City of Portland, Maine – Building or Use Permit Application 389 Congress Street, 04101, Tel: (207) 874-8703, FAX: 874-8716

Location of Construction: Village Cafe - 112 Newbury St. 04101		Owner: John Reali	Phone: 772-5320	Permit No: 990754
Owner Address: 112 Newbury Street		Lessee/Buyer's Name:	Phone:	BusinessName:
Contractor Name: Thomas Libby Construction		Address: 107 Veranda St. Ptland, ME 04103		Phone:
Past Use: Restaurant	Proposed Use: Same	COST OF WORK: \$ 6,000	PERMIT FEE: \$ 60.00	Permit Issued: PERMIT ISSUED JUL 16 1999 CITY OF PORTLAND Zone: CBL
		FIRE DEPT. <input checked="" type="checkbox"/> Approved <input type="checkbox"/> Denied	INSPECTION: Use Group: Type:	
		Signature: <i>[Signature]</i>	Signature: <i>[Signature]</i>	
Proposed Project Description: Build 15 x 33 Deck		PEDESTRIAN ACTIVITIES DISTRICT (P.A.D.)		Zoning Approval: <i>[Signature]</i> 7/12/99
		Action: Approved <input type="checkbox"/>	Approved with Conditions: <input type="checkbox"/>	Special Zone or Reviews:
		Denied <input type="checkbox"/>	Date:	<input type="checkbox"/> Shoreland

BUILDING PERMIT REPORT

DATE: 7/15/99 ADDRESS: 112 Newbury St CBL: 20-D-32
 REASON FOR PERMIT: Construct 15 x 33 Deck
 BUI

SECTION 1014.6 TREADS & RISERS

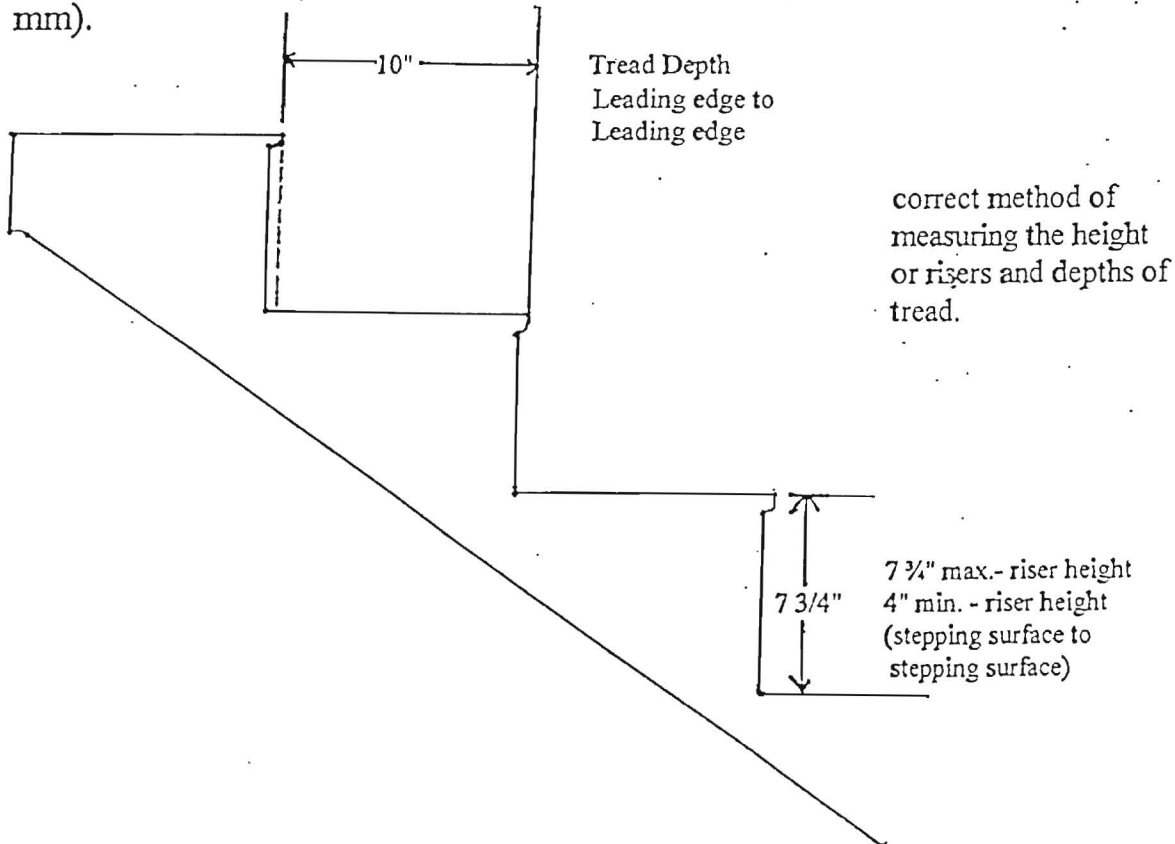
EXCEPTION: NO. 8 - In occupancies in use group R-3, within dwelling units in occupancies Use group R-2 and in occupancies in Use Group U which are accessory to an occupancy in Use Group R-3. The maximum riser height shall be 7 3/4 inches (197mm) and the minimum tread depth shall be 10 inches (254mm). A nosing not less than 3/4 inches but not more than 1 1/4 inches (32mm) shall be provided on stairways with solid risers where the depth is less than 11 inches (279 mm).
